Planning and Development Services Division Vote Report

Meeting Date: January 9, 2017

Petition: **P.Z. 05-2016 Wildhorse Baxter Center, C148B (Shelbourne Senior Living):**
A request for a zoning map amendment from a “C-8” Planned Commercial District to a “UC” Urban Core District for 5.21 acres located south of Wild Horse Creek Road and east of its intersection with Baxter Road (18T630283).

PRELIMINARY DEVELOPMENT PLAN

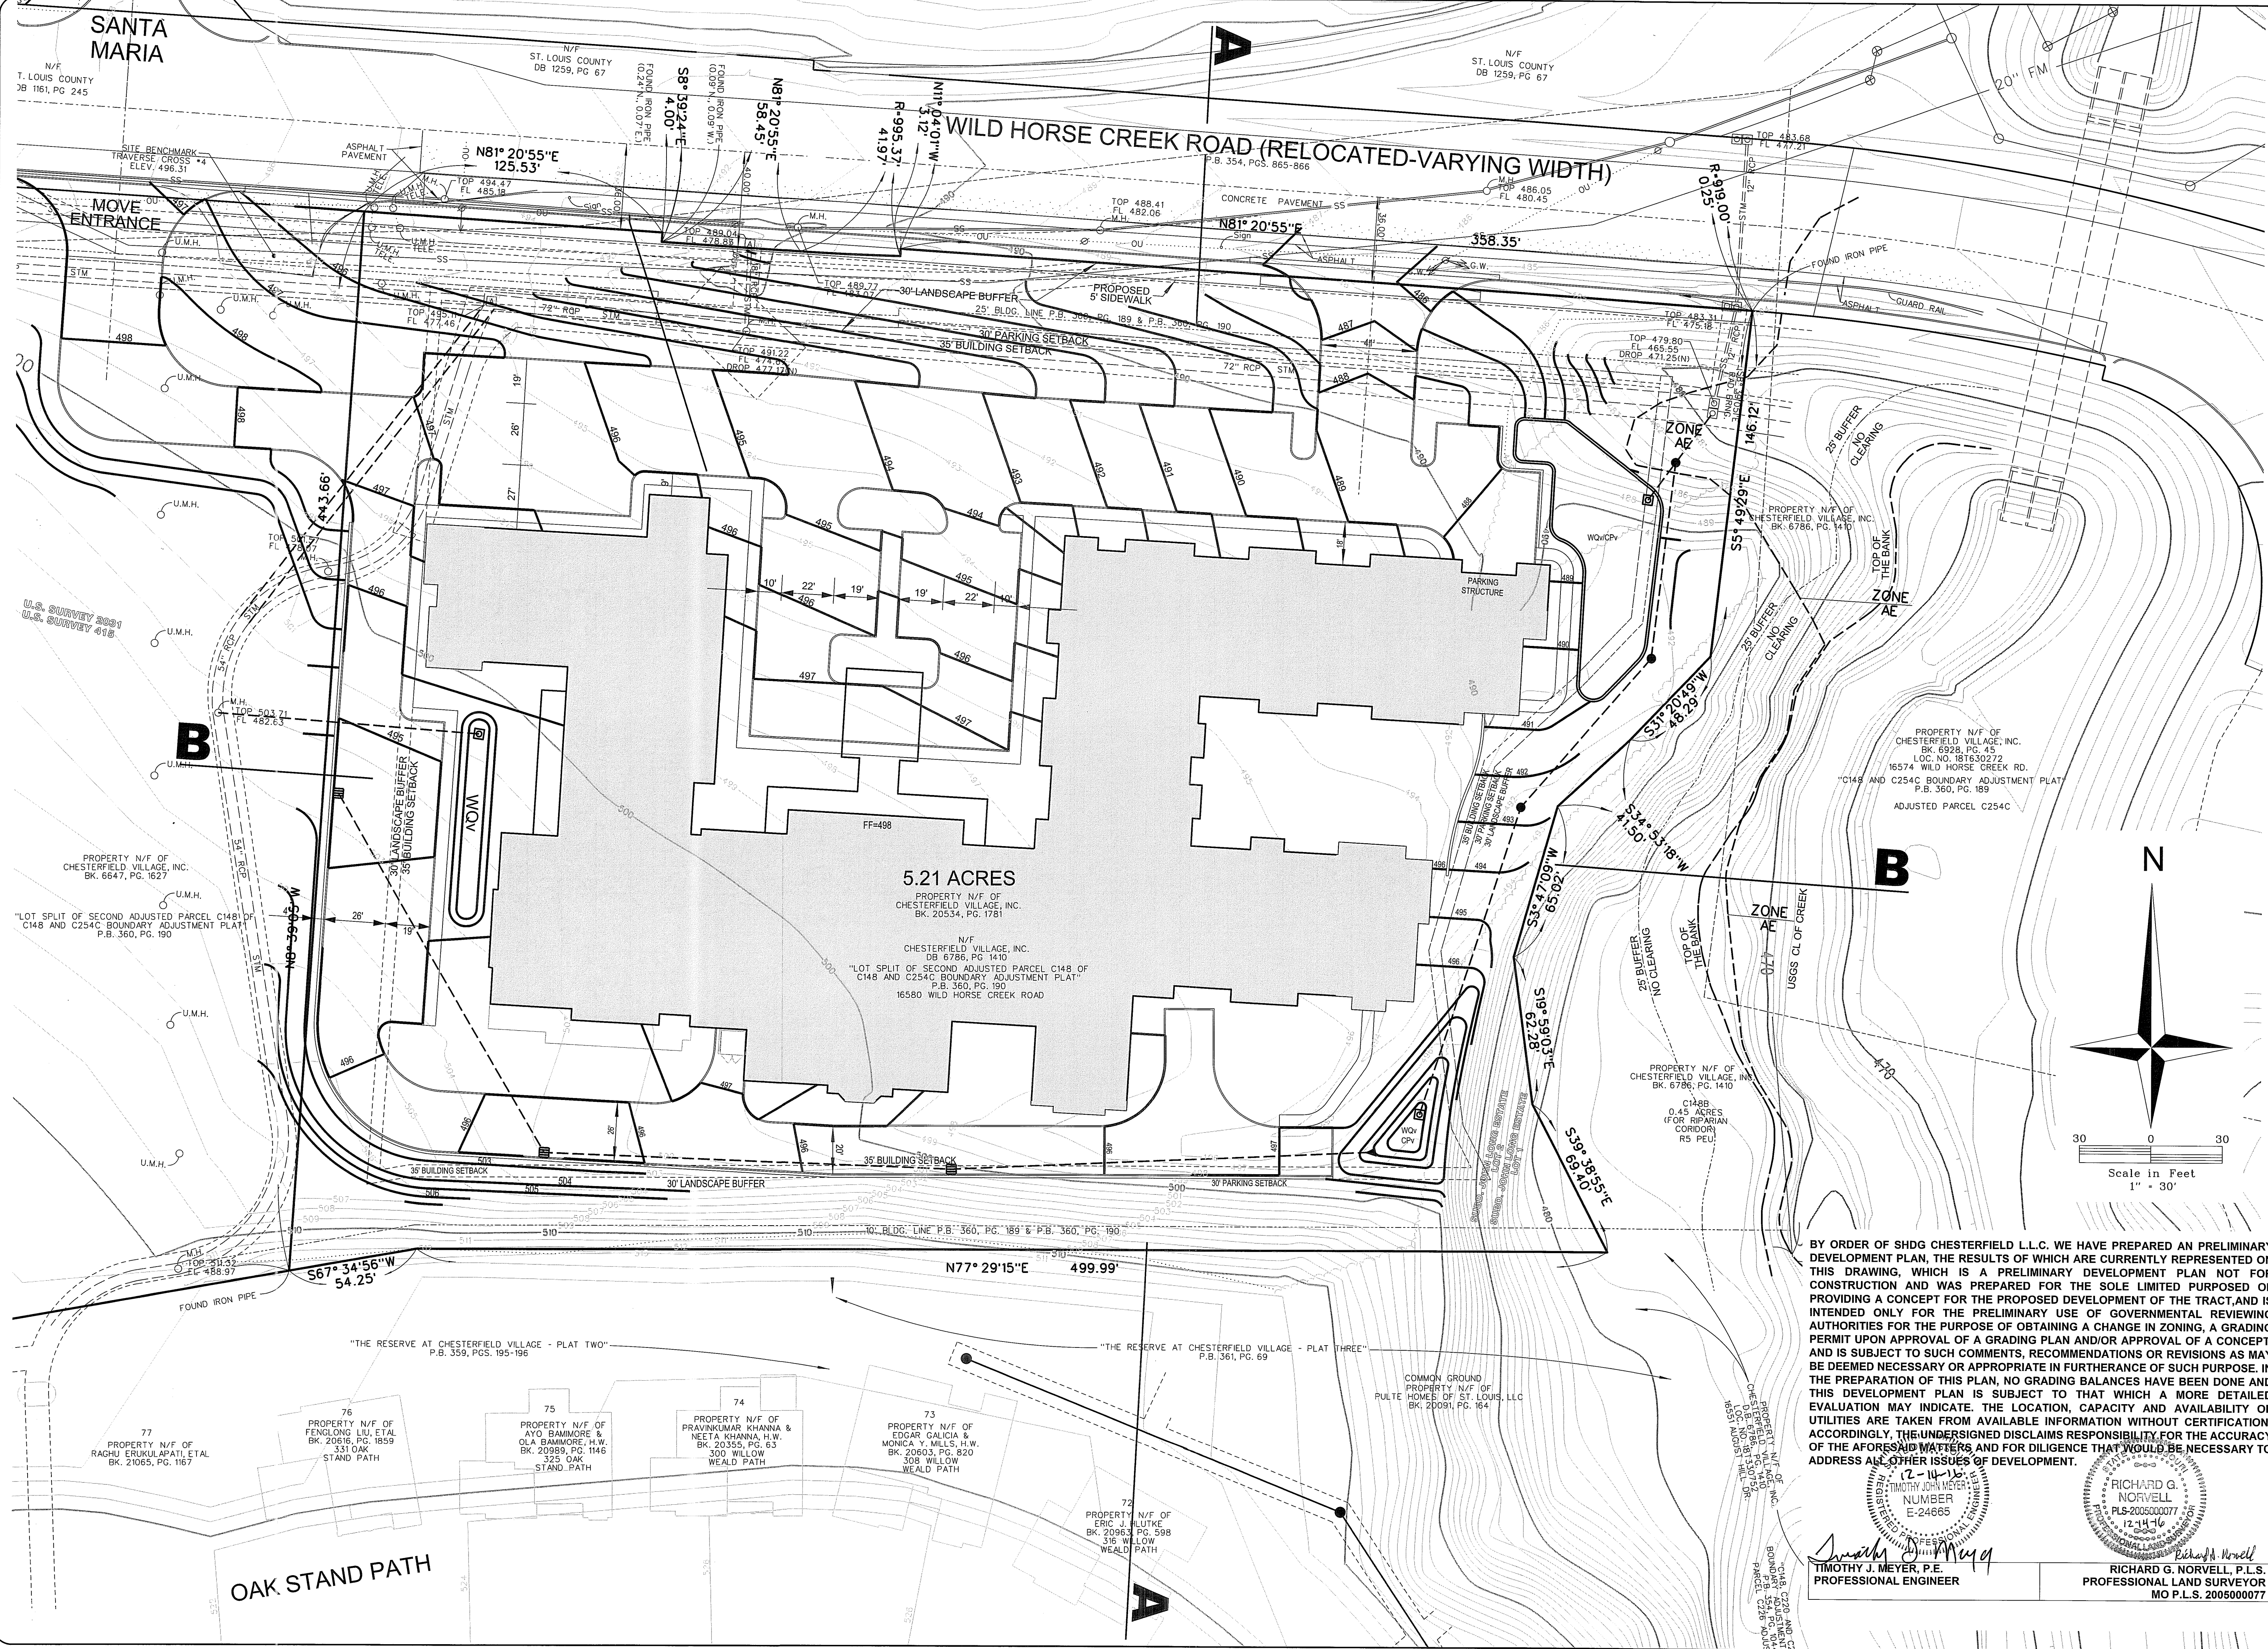
3. Concerns were expressed regarding the proposed height of the facility – specifically the four story portions of the building. Clarify the Preliminary Plan to clearly reflect the location of 3-story sections versus 4-story sections of the building and consider revising the proposal to eliminate any 4-story portions of the building.

6. The proposed off-site access location does not comply with access management standards. A restriction preventing use of this driveway location until such time as the access is brought into compliance with City and County access management standards will be included in the Attachment 'A' for the development.

After much study and review of alternative designs and plans, Petitioner has developed a concept design and plan that reduces the height to three stories. To accomplish that result Petitioner requests that the Planning Commission modify the West setback as shown on the revised Preliminary Plan submitted contemporaneously with this letter. Reducing the setback on the West has no adverse effect. The adjacent commercially zoned parcel on the West (C-148A) is owned by the same entity that owns the subject site (C-148B), and it has no objection to a reduction of the setback on the West.

Because of the topography, expanding the buffer has no benefit. In addition, the reduction in height does provide a significant benefit to the adjoining residences and could not be accomplished if the buffer is expanded beyond what is shown on the revised Preliminary Plan.

Petitioner agrees to relocate the off-site access location as requested by staff, and the owner of the off-site Parcel (C-148A) has consented to that relocation.
